TECHNICAL BULLETIN

Diesel Engine/Fuel Tank Preventative Maintenance

Bulletin #:	Rev:	Created by:	Date:
83629	-	RZV	FEB 8, 2012

ECR # 16669

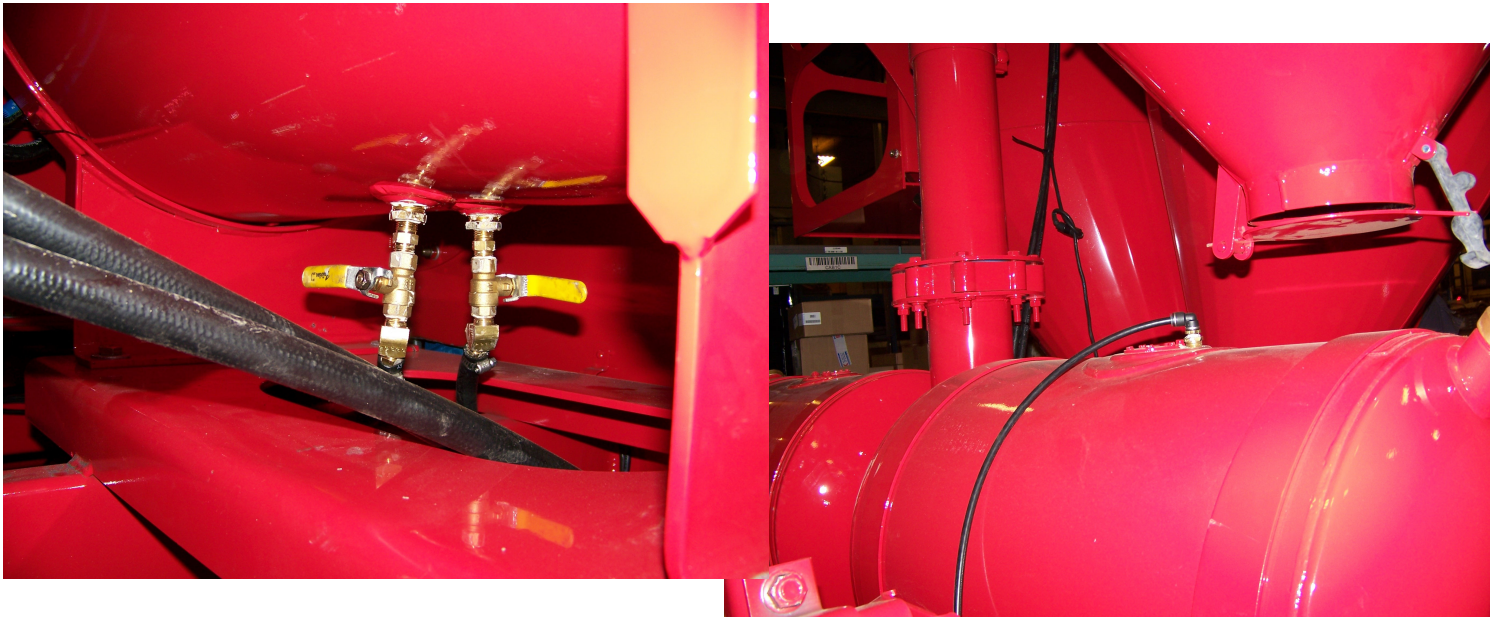
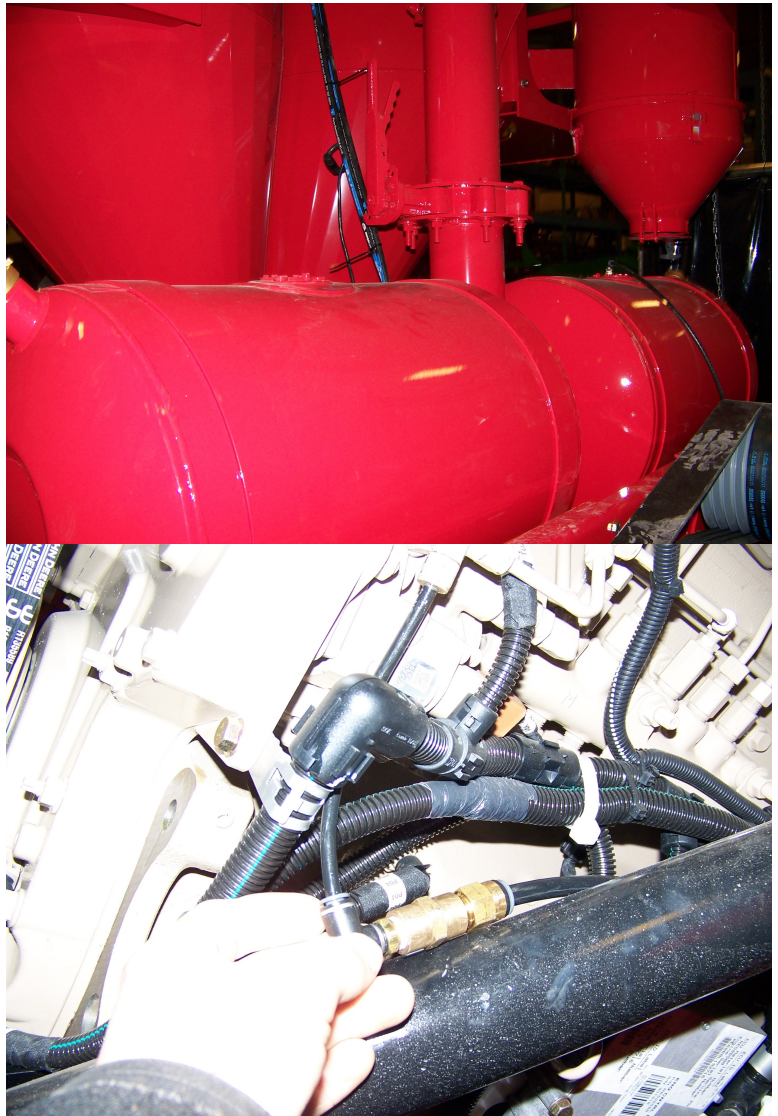
Engines installed between Aug 2010 and Jan 2012 have been failing due to insufficient line size going to and from the fuel tanks. At the recommendation of the engine supplier, a couple of things should be done to stop this from happening in the future.

1. Return line should go into the secondary tank not the primary tank.
2. Return line should be 3/8" instead of the 1/4" line.
3. Line connecting the tank to the engine should be a 1/2" line instead of 3/8".

See images of the corrections that need to be made.
